MANPRINT ASSESSMENT OF THE
HIGH MOBILITY MULTIPURPOSE WHEELED VEHICLE
HEAVY VARIANT (HMMWV-HV)
(Contract MDA903-83-C-0033)

March 1988

MANPRINT ASSESSMENT:

HIGH MOBILITY MULTIPURPOSE WHEELED VEHICLE HEAVY VARIANT (HMMWV-HV)

Figure 3.2.1. Rear door latching mechanism.

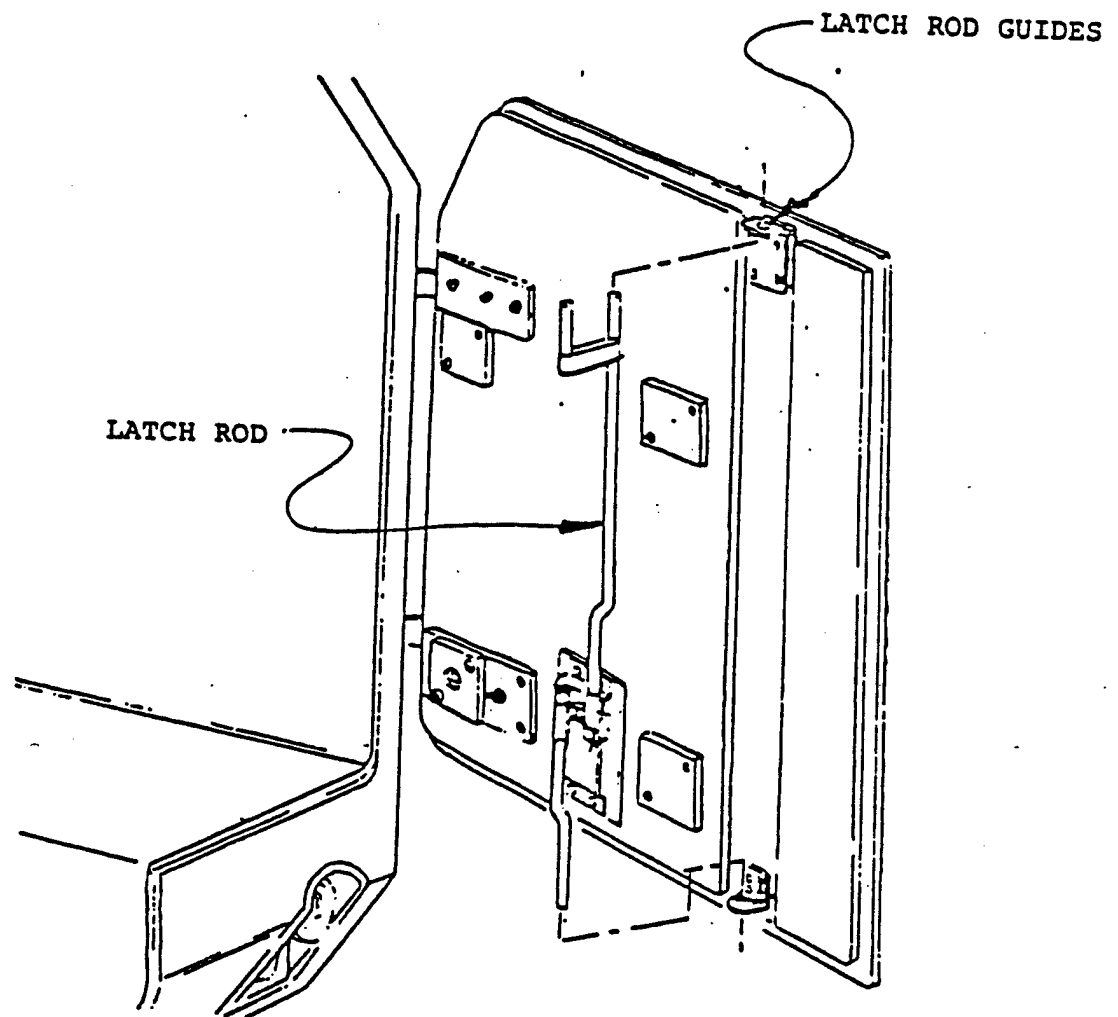
The rear doors for both the mini- and maxi-ambulances have inadvertently opened during normal operation. The hardware and latching mechanisms involved are shown in Figure 3.2.1.

Unsecured doors pose a safety hazard to personnel inside the enclosure. May require unscheduled stopping for the ambulance.

To achieve positive locking of the rear doors:

Figure 3.2.2.1. Rear entry steps.

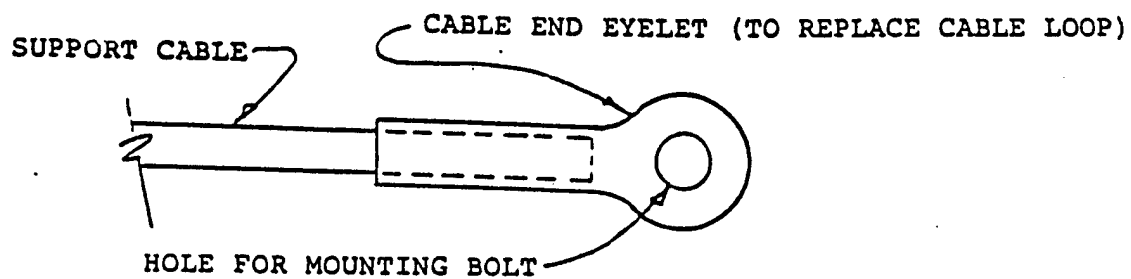
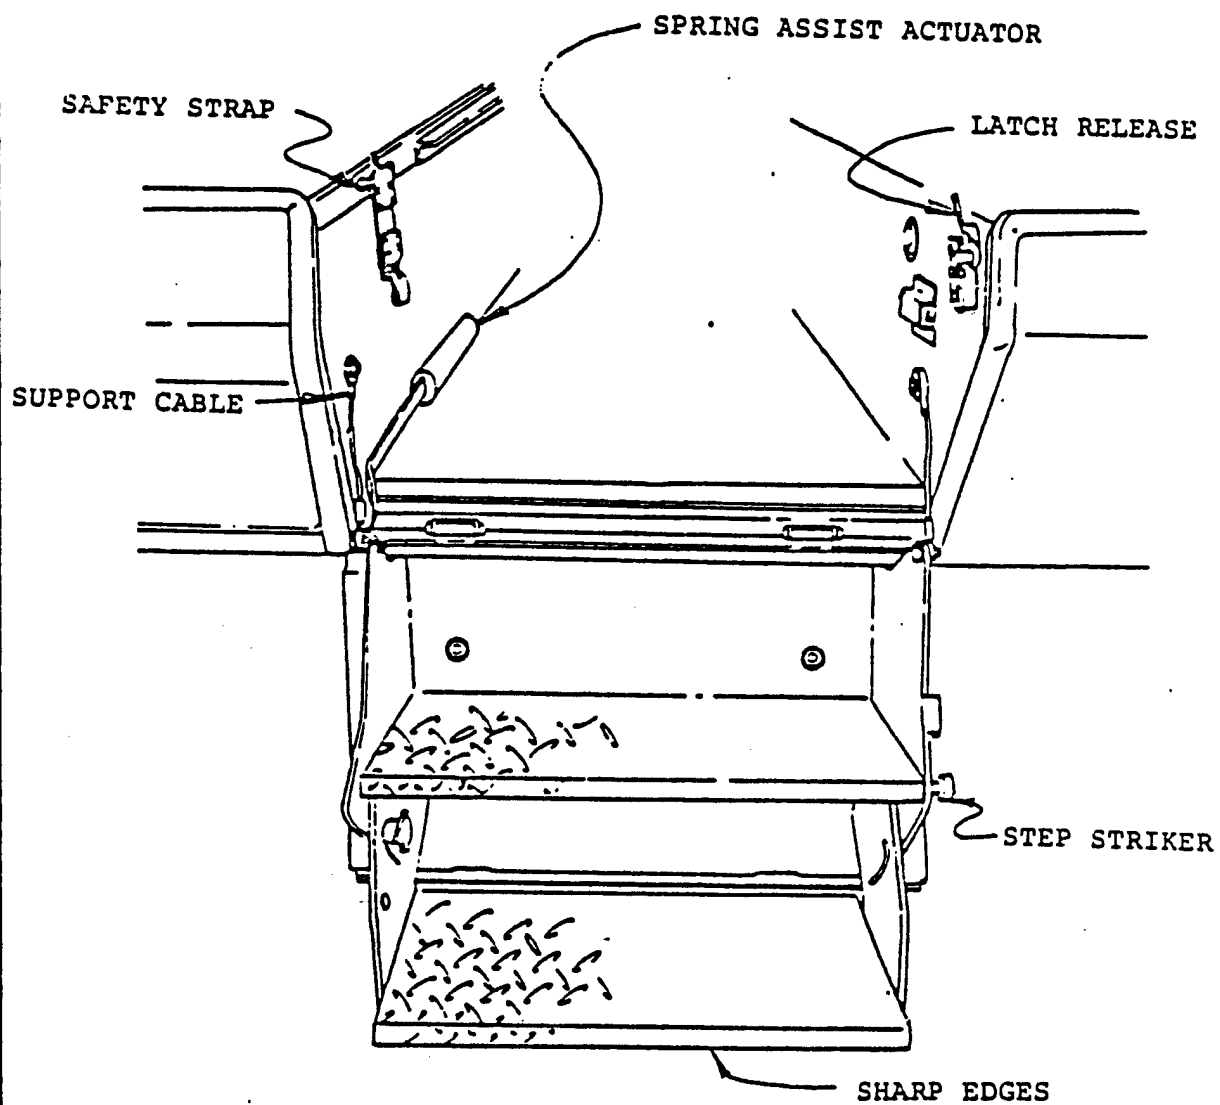
- a. The stair release latch is stiff, prone to sticking, and interferes with the litter support strap in the maxi-ambulance (see Figure 3.2.2.1).
- b. The safety strap for stowed position is hidden from operator's view while the operator is attaching or unattaching the strap hook.
- c. Sharp edges on steps have caused lacerations of the operators' hands.
- d. The stair support cables have come off of their attachment fasteners (see Figure 3.2.2.2).
- e. The mini-ambulance step seat (used while steps are in stowed position inside the van) restricts the headroom of a seated aidman.

a. Design the latch with an increased compound lever advantage. Change the direction of the release motion 90 degrees to existing. Move litter support strap to avoid interference.

b. Design a positive latch lock that eliminates the safety strap requirement. Integrate a dual latch system for both sides of the step that mounts to the steps with a single release handle. This would move the step striker from the steps to inside the van. (AM General installed a dual latch system at the end of the operational test; no functional data is available.)

c. All sharp edges should be eliminated.

d. Stair support cables could be redesigned to incorporate the cable and eyelet (see Figure 3.2.2.1).

DESCRIPTION
Figure 3.2.2.2. Support cable.

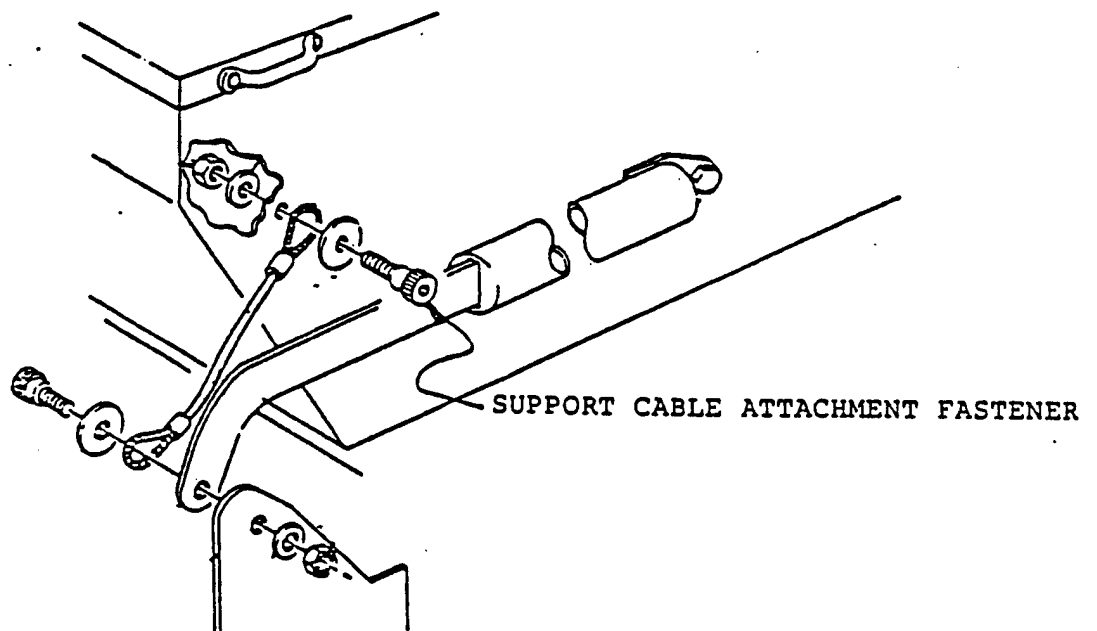
The step latch hardware, when fouled with dust, malfunctions. The motion to actuate the release lever is lateral to operator's frontal plane and is difficult to grasp in order to release. The stair support cable loops wear, increasing their diameter and allowing them to come off their mounting fasteners (see Figure 3.2.2.2).

Figure 3.2.3. Aidman and ambulatory patient securing.

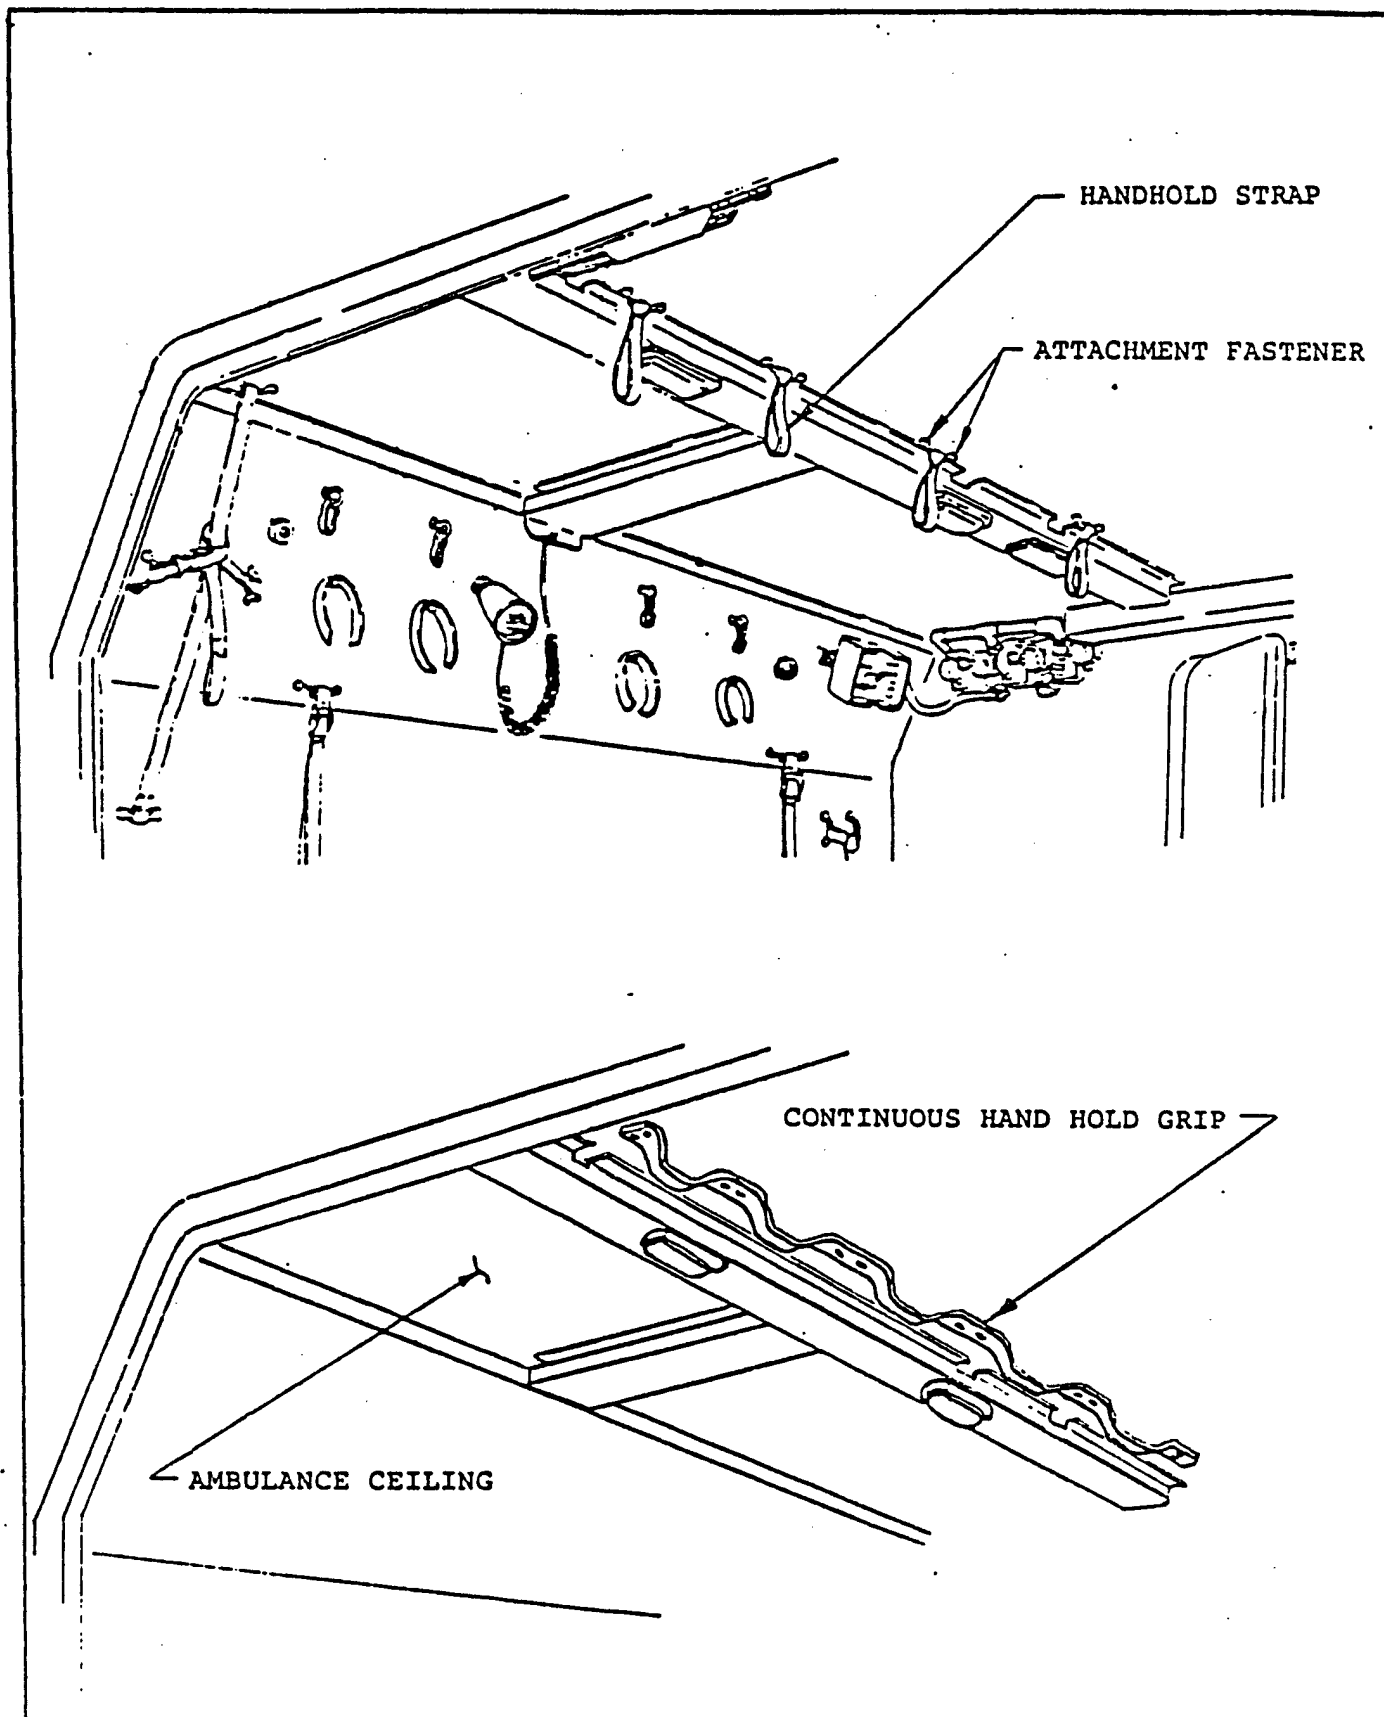
c. The mini-ambulance has handhold straps for use by seated ambulatory patients. The securing fasteners frequently failed, rendering the strap useless. It is also difficult to slide hands in and out of the hand strap loop (see Figure 3.2.3).

a. Incorporate a self-winding (retractable) seat belt restraint into the split between the seat and back of the ambulatory seat in the mini-ambulance. Incorporate this seat and restraint system into the maxi-ambulance (the maxi-ambulance upper litter rack could then tilt up to provide a storage area for ambulatory patient personal gear).

b. Add four handhold straps into the maxi-ambulance similar to the hand straps in the mini-ambulance. This will augment the existing four handholds provided by the looped upper litter support straps.

c. Incorporate a handhold system such as a continuous handhold strap as shown in the lower portion of Figure 3.2.3. This will give aidmen a handhold while attending to upper litter patients in the maxi-ambulance.
